PCN-20201003 TE0890-01 SPI Flash Change

Company	Trenz Electronic GmbH
PCN Number	PCN-20201003
Title	TE0890-01 SPI Flash Change
Subject	BOM change
Issue Date	2020-10-06

This change affects all Trenz Electronic TE0890 modules of revision 01.

Locate Flash (U6) at top side of PCB:

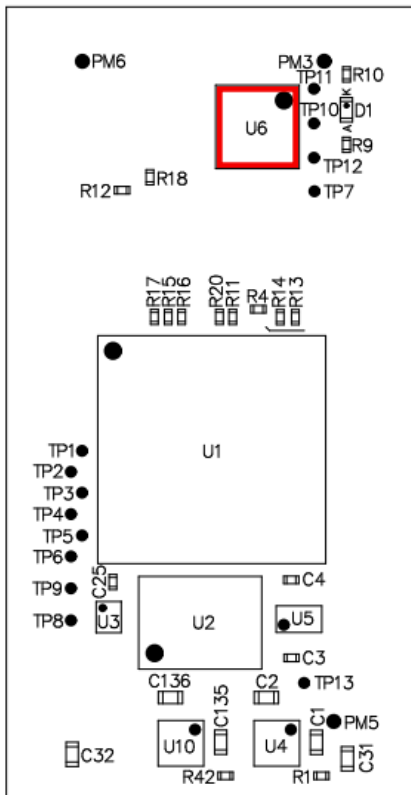
#1 Change SPI Flash from N25Q064A13ESE40F to IS25LP064D-JBLE

Type: BOM change

Reason: Old flash is obsolete.

Impact: JEDEC ID changes from BA17h to 6017h and manufacturer ID from 20h to 9Dh.
